JRC questions to SIGTP-02-18

2nd SIG TP meeting, Jan 30, 31 and Feb 01, 2024

Typical Specification of Battery Pack and Cell for xEV

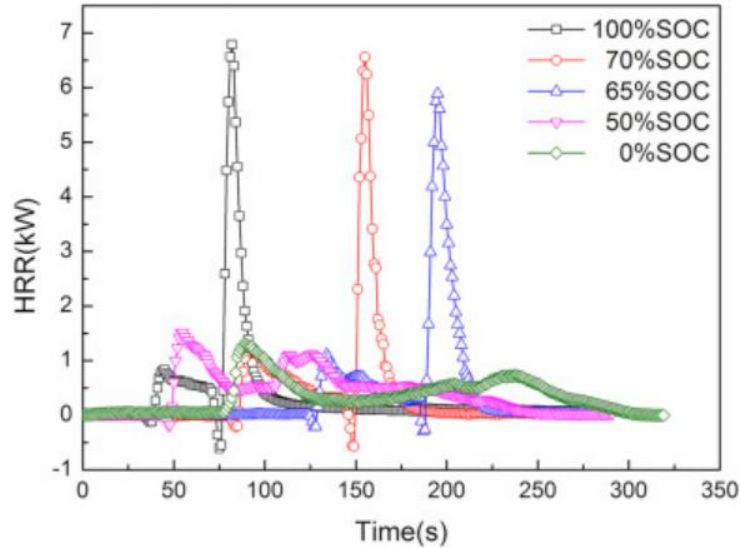
Literature data, collected by JRC, shows that:

- Ranges for cell capacity and cell specific energy for HEV and BEV/PHEV vehicles are similar
- Battery pack energy and weight for BEV/PHEV and HEV differ (less than) a factor of two
- Battery packs in both cases are high voltage systems
